UNITED STATES PATENT AND TRADEMARK OFFICE

APPLICATION NO.	FILING DATE	FIRST NAMED INVENTOR	ATTORNEY DOCKET NO.	CONFIRMATION NO.
10/606,210	06/26/2003	Yoshikazu Hanada	Q76020	4368
23373	7590	11/16/2005	EXAMINER	
SUGHRUE MION, PLLC 2100 PENNSYLVANIA AVENUE, N.W. SUITE 800 WASHINGTON, DC 20037			ADDISU, SARA	
			ART UNIT	PAPER NUMBER
			3722

Office Action Summary	Application No.		Applicant(s)	
	10/606,210		HANADA, YOSHIKAZU	
	Examiner		Art Unit	
	Sara Addisu		3722

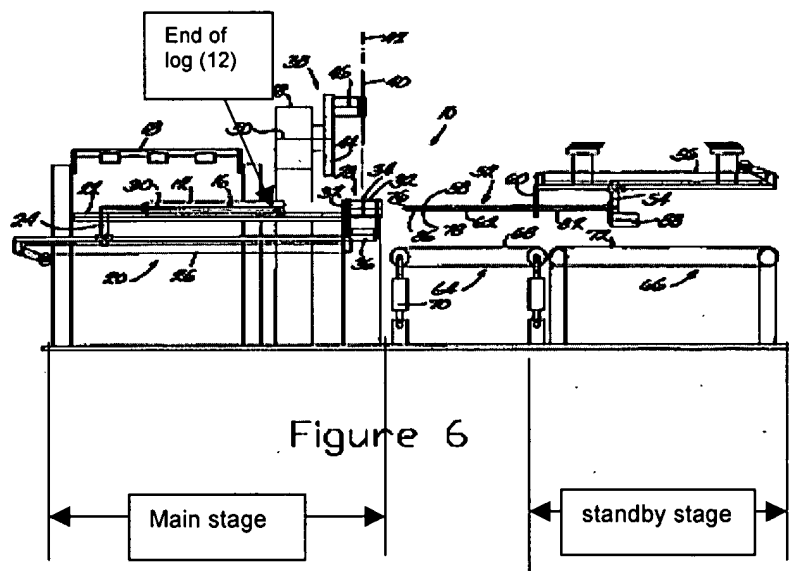
Butterworth teaches a log saw apparatus and method as set forth in the above rejection. Furthermore, Butterworth teaches the cutting mandrel (52) teaches mandrel (152) including a shaft (174) that is divided into first and second sections (P1 and P2) and a recess (158) formed in the third section (P3) ('853, figure 3 and Col. 8, lines 23-36). Sections P1 and P2 have protrusion at its end that join to form the recess (158) (see figure above: under 102 (b)).
